SOLICITATION NAME	Construction Services at Five Points Phase 3 C18016	ADDENDUM NUMBER	2	DATE	11-28-17
--------------------------	--	------------------------	----------	-------------	-----------------

DOCUMENT 00 91 13.02 – ADDENDUM 2

- A. Project Identification: Five Point – Phase 3.
 - 1. Project Location: 304 S. Kyle Street, Knoxville, TN 37915.
- B. Owner: Knoxville Community Development Corporation, 901 Broadway, N.E., Knoxville, Tennessee 37917-6699.
- C. Architect: BarberMcMurry architects, 505 Market Street, Suite 300, Knoxville, TN 37902-2175. Phone: 865-934-1915. Fax: 865-546-0242.
- D. Architect Project Number: 166200
- E. Date of Addendum: 28 November 2017.

**M/P/FP INFORMATION
ADDENDUM #2**

ES101
SITE LIGHTING PLAN

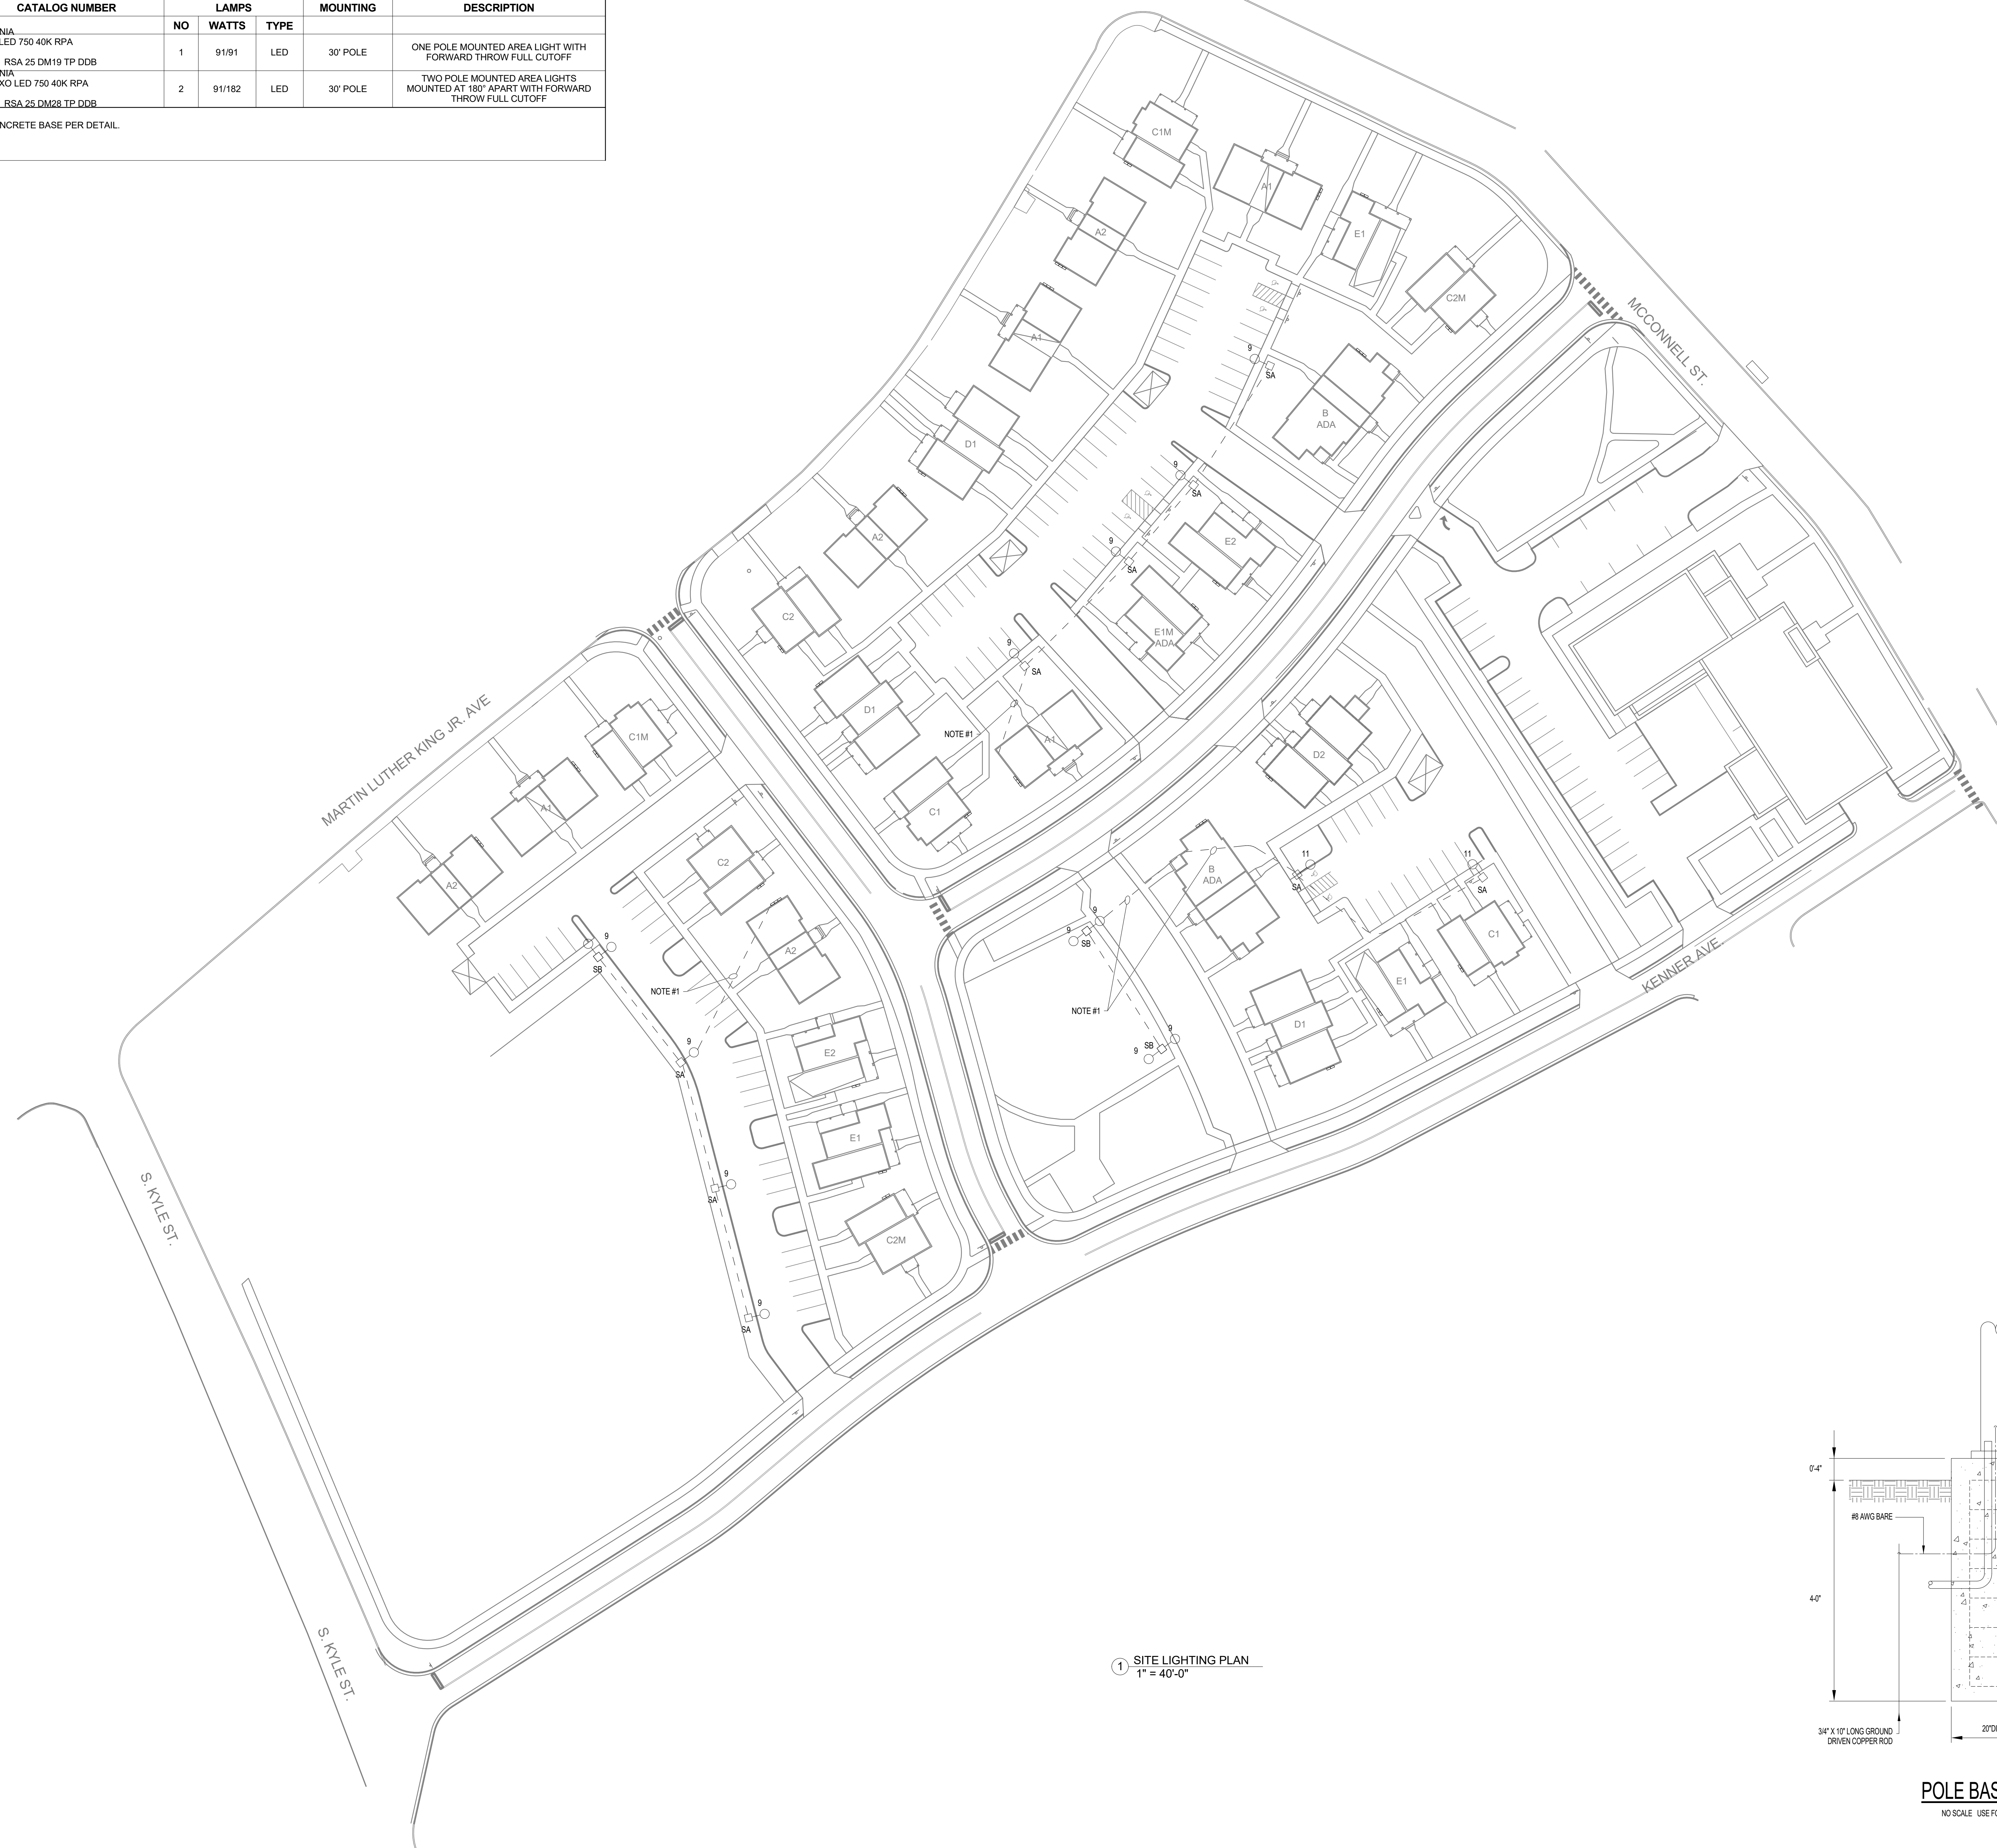
Q6	Drawing ES301: The Notes do not seem to match up on this page. Can you identify Pullbox requirements?
	The reference notes for ES301 have been updated and revised sheet is included in Addendum 2.
